Notice of Allowability

10/799,675

DETAILED ACTION

FIG. 5

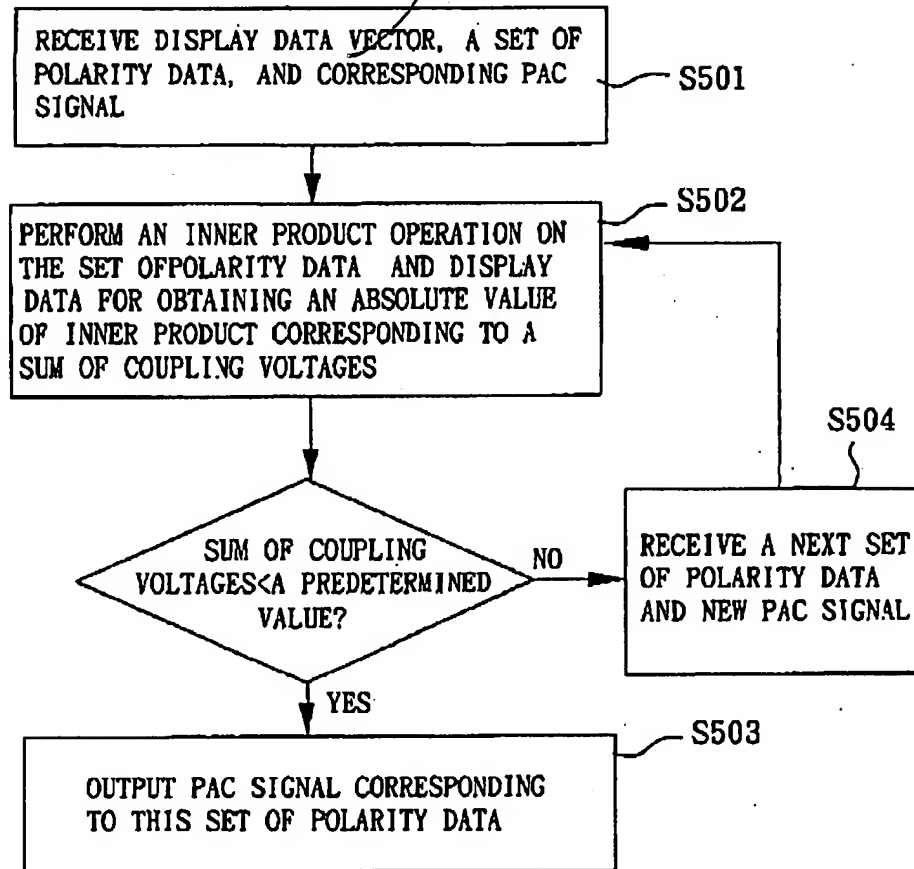
2. The drawings are objected to because typo or clerical errors for the claimed terms found in the Replacement Sheets for Figs. 5 and 8 submitted on June 13, 2007 as follows:

In Fig. 5, step S501: "DISPLAY.DATA VECTOR" must be changed to --DISPLAY DATA--;

FIG. 8

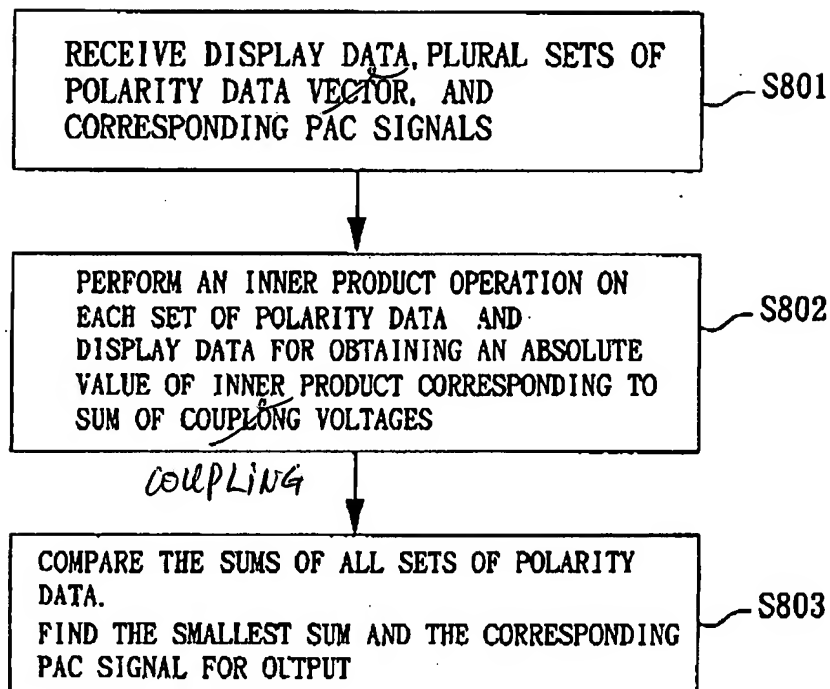
In Fig. 8, Step S801: "POLARITY DATA VECTOR" must be changed to --POLARITY DATA--; and in step S802: "COUPLONG VOLTAGE" must be changed to --COUPLING VOLTAGES--, see that attached Figs, 5 and 8. This is needed in order to avoid unnecessary correction after the issue of the letter of U.S. patent.
